APPLICATION NO.	FILING DATE	FIRST NAMED INVENTOR	ATTORNEY DOCKET NO.	CONFIRMATION NO.
10/743,458	12/23/2003	Tsuyoshi Kubota	90606.2/wa	8146
54071 7590 04/11/2007 YAMAHA HATSUDOKI KABUSHIKI KAISHA C/O KEATING & BENNETT, LLP 8180 GREENSBORO DRIVE SUITE 850 MCLEAN, VA 22102			EXAMINER KIM, CHONG HWA	
			ART UNIT 2167	PAPER NUMBER

Office Action Summary	Application No. 10/743,458	Applicant(s) KUBOTA ET AL.	
	Examiner Chong H. Kim	Art Unit 2167

DETAILED ACTION

FIG. 19

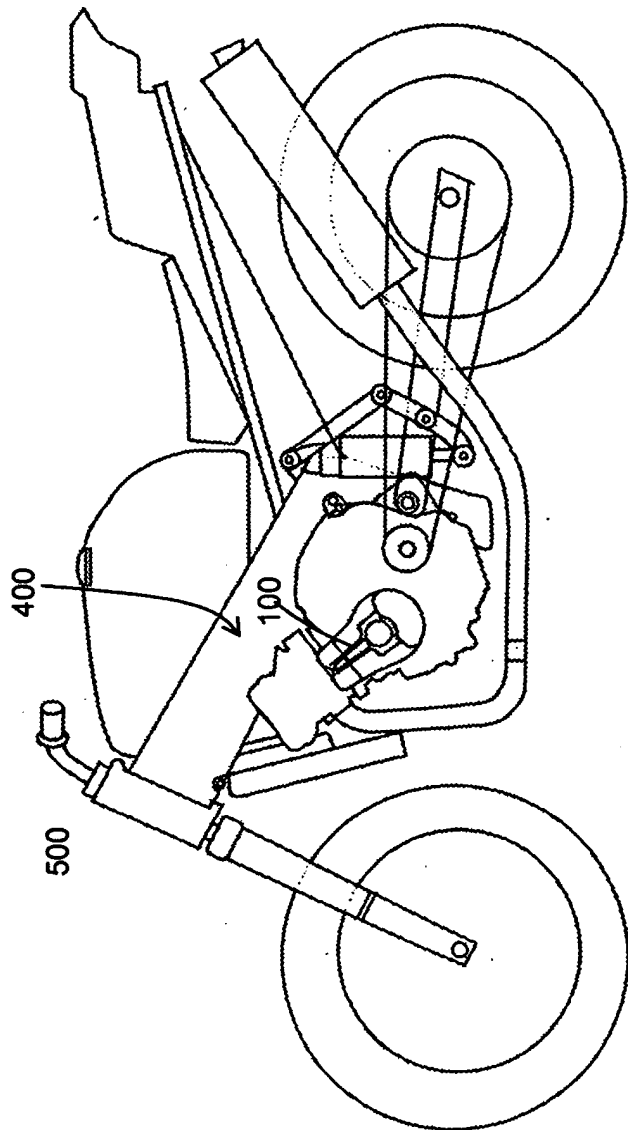
1. The drawing was received on Feb 7, 2007. The drawing is not approved for containing new matter.
2. The drawings are objected to under 37 CFR 1.83(a). The drawings must show every feature of the invention specified in the claims. Therefore, the engine as recited in claims 23 and 31; and the vehicle as recited in claims 24 and 32 must be shown or the feature(s) canceled from the claim(s). No new matter should be entered.

3. The amendment filed Feb 7, 2007 is objected to under 35 U.S.C. 132(a) because it introduces new matter into the disclosure. 35 U.S.C. 132(a) states that no amendment shall introduce new matter into the disclosure of the invention. The added material which is not supported by the original disclosure is as follows: Fig. 19 as submitted in the drawing and the new paragraph on page 10 line 26 to indicate such illustration.

not approved ca 4/6/07

Applicant is required to cancel the new matter in the reply to this Office Action.
